SAN ANSELMO FLOOD RISK REDUCTION PROJECT

Final Environmental Impact Report
Volume 2 - Response to Comments
State Clearinghouse No. 2017042041

Prepared for
Marin County Flood Control and Water
Conservation District

Figure 3-14b
Water Surface Elevation Change With Project
25 - Year Flood Event: Upper San Anselmo

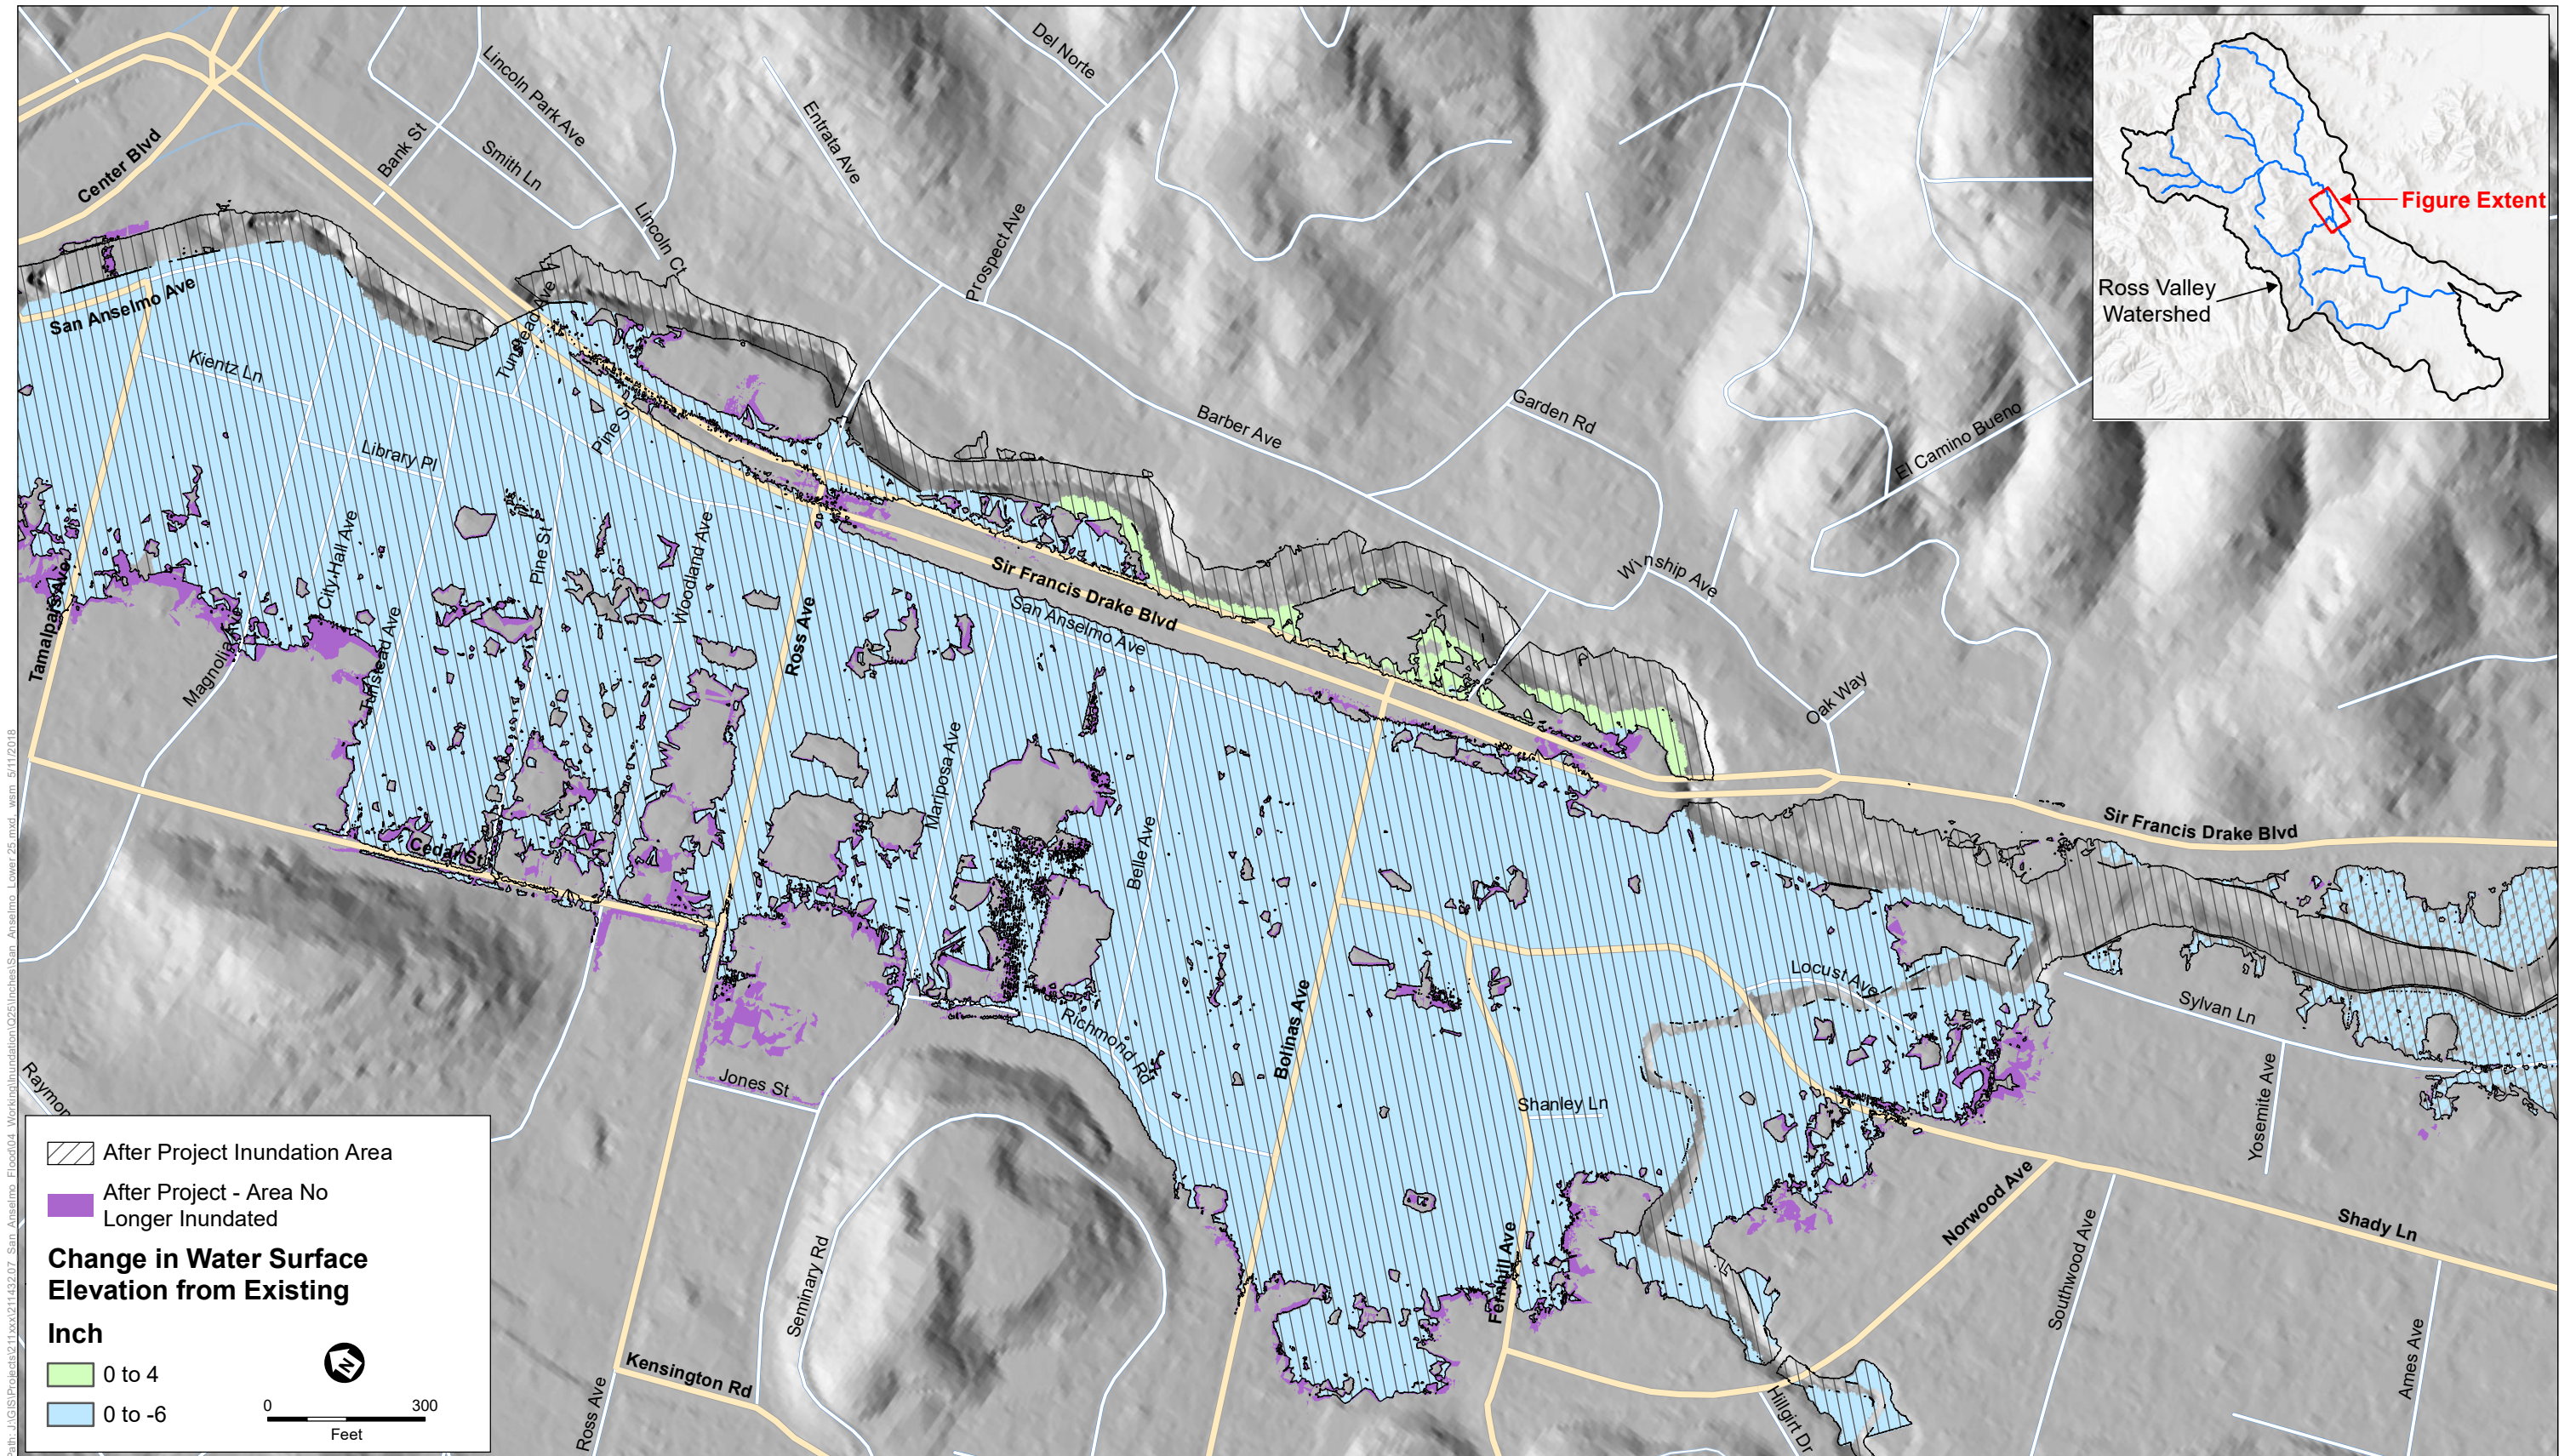
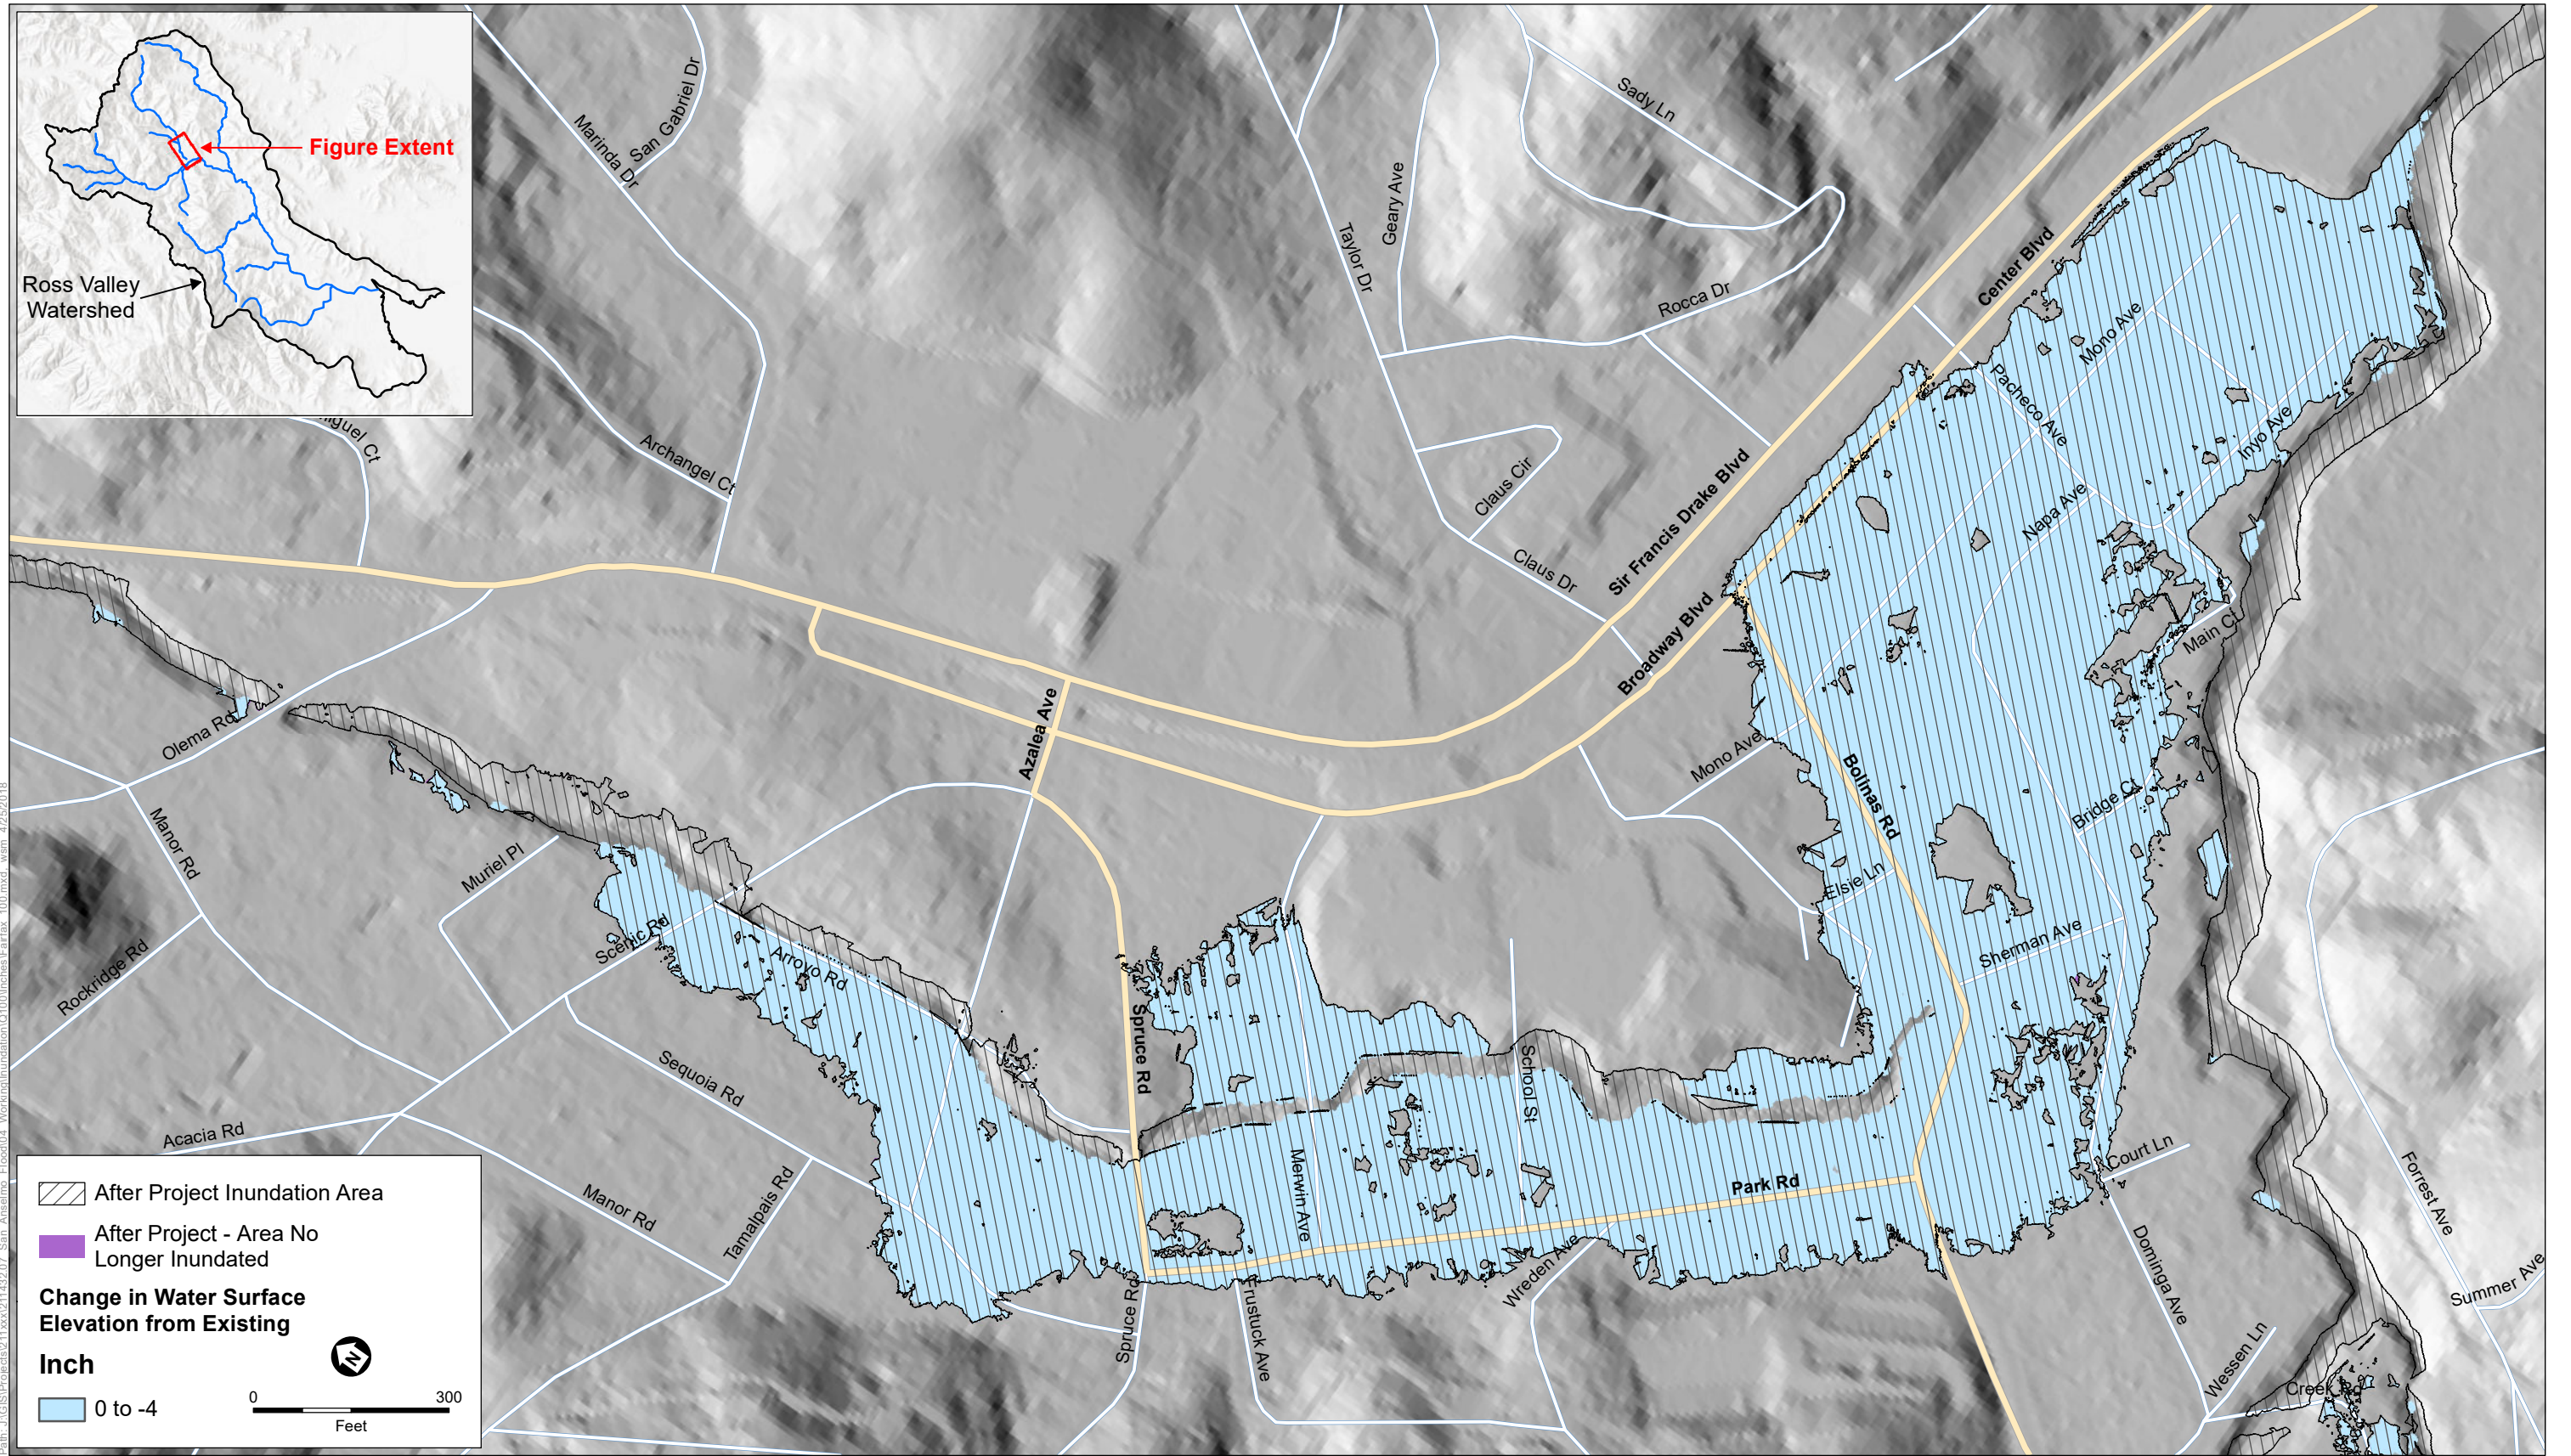
Figures in Chapter 3 (figures 3-13, 3-14, and 3-15), that show water surface elevation, change with project are not easy to interpret. It appears that the purple areas, labeled "After Project Inundation Reduction Area" would be removed from flooded areas during the specified events. However, use of the word "reduction" suggests that they would still be inundated, just to a lesser extent.

Draft EIR Figures 3-13a-c, 3-14a-c, and 3-15a-c have been revised in response to this comment. The revisions to these figures do not result in any changes to the environmental analysis in the Draft EIR.

In response to Comments B1-5 and PH-2, the legend descriptions associated with purple areas of Draft EIR Figures 3-13a-c, 3-14a-c, and 3-15a-c (Draft EIR pages 3-25 through 3-33) have been revised to read:

After Project ~~Inundation Reduction Area~~ – Area No Longer Inundated
